**GS# 104-215 Jones Hall Interior Renovations  
Mississippi University for Women**

Addendum No. 2

**FIRE ALARM - 5TH FLOOR PLAN**

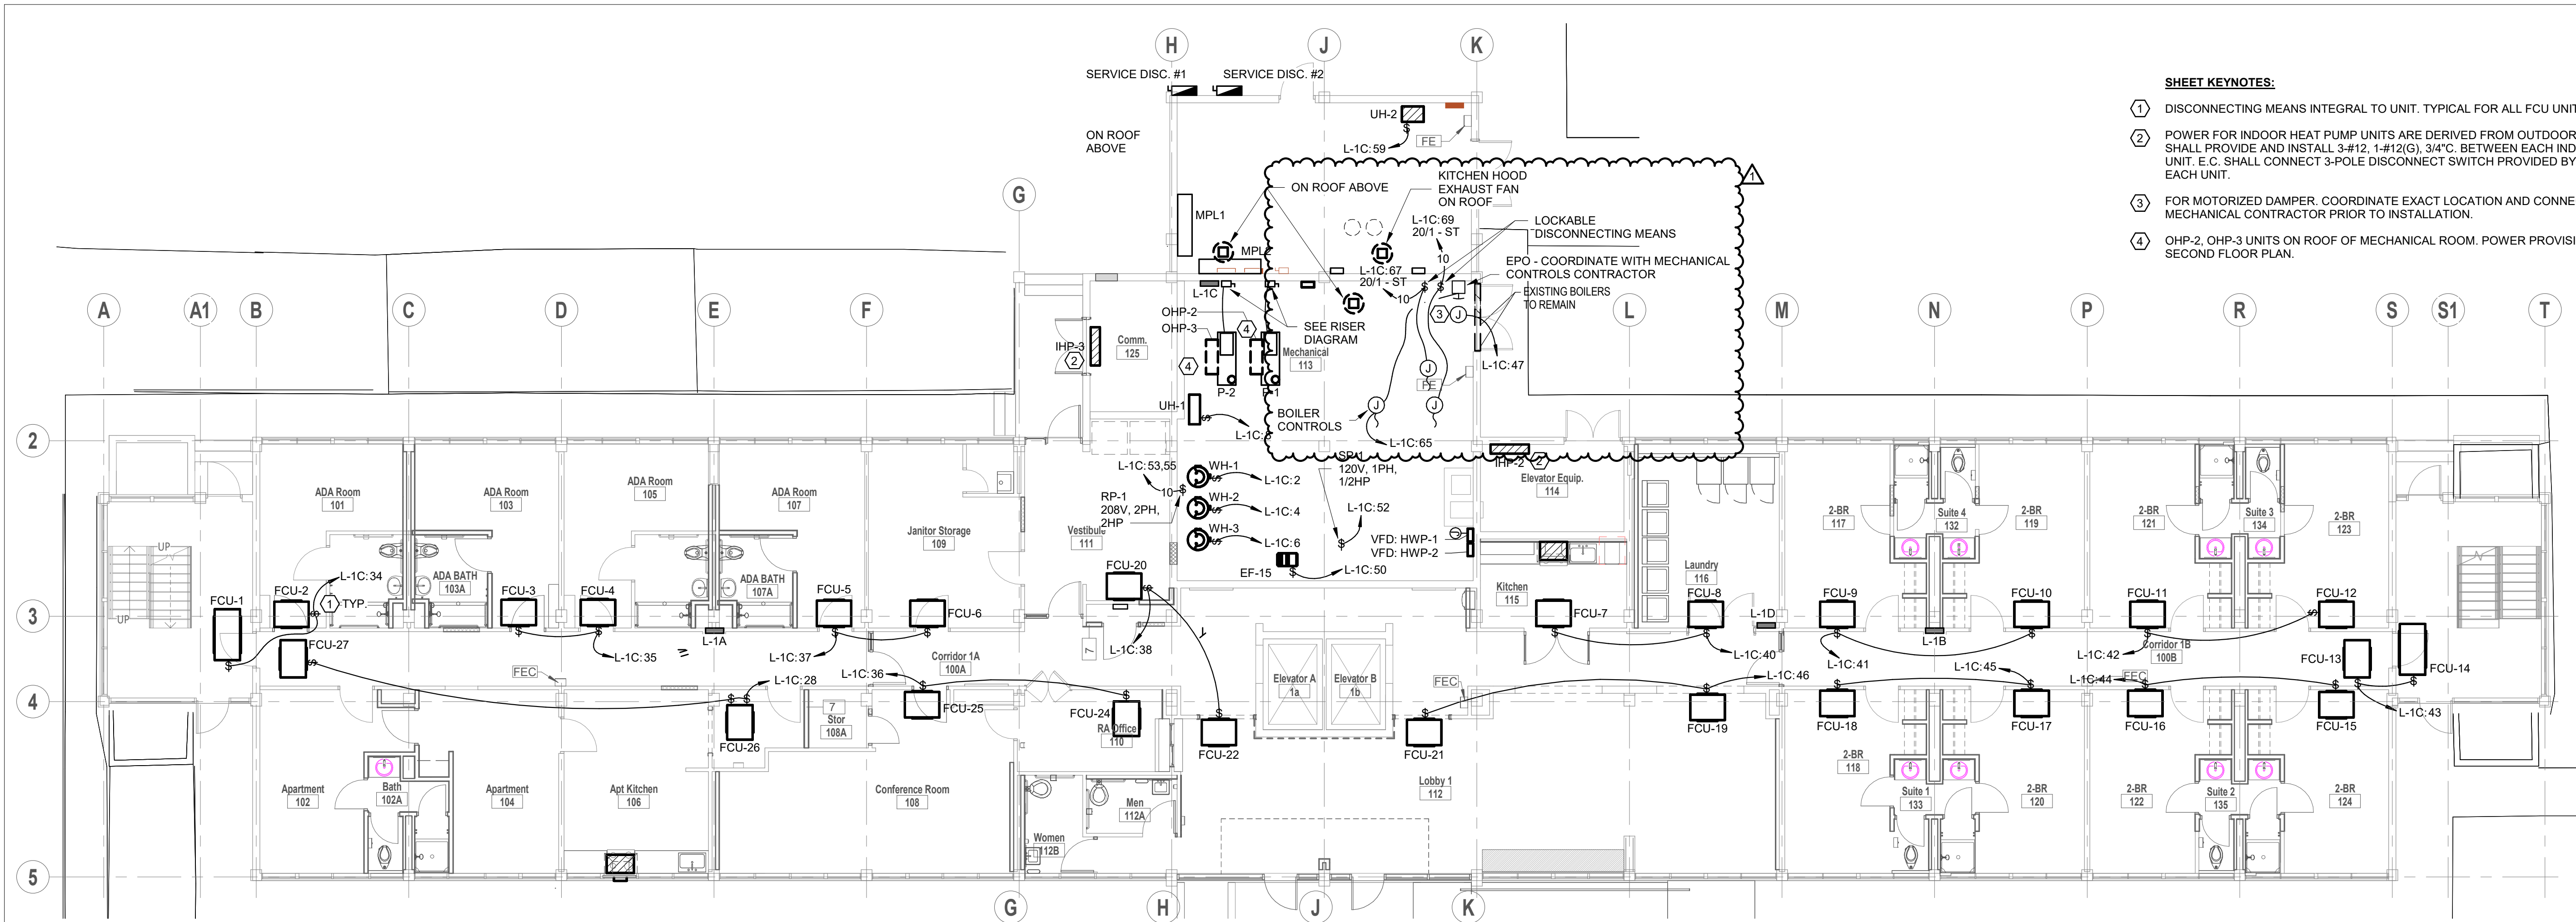
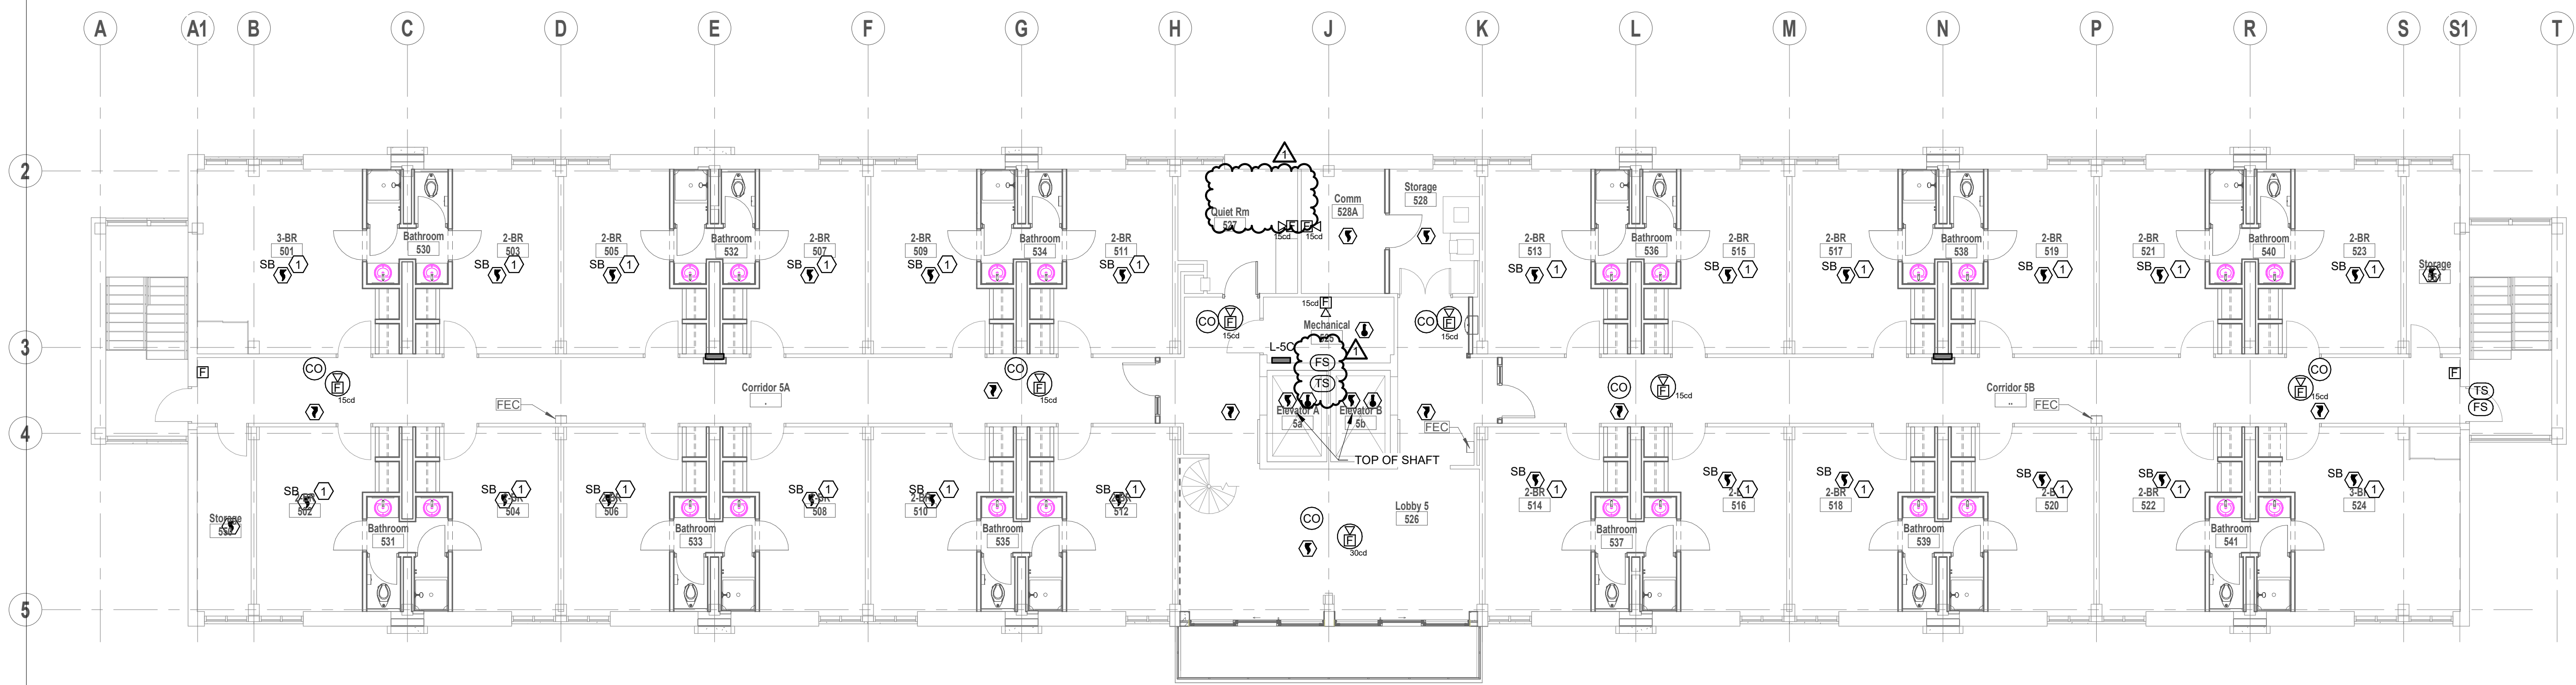
- x. Revise Sheet E405 and replace with attached Sheet E405. Revisions include adding flow and tamper switches to top of elevator shaft. Moved duct detectors from Sheet E405 to Sheet E306.
- y. Revise Sheet E501 and replace with attached Sheet E501. Revisions include adding power provisions for the existing boilers as well as boiler controls. Relocated EPO switch to top wall of the mechanical room.
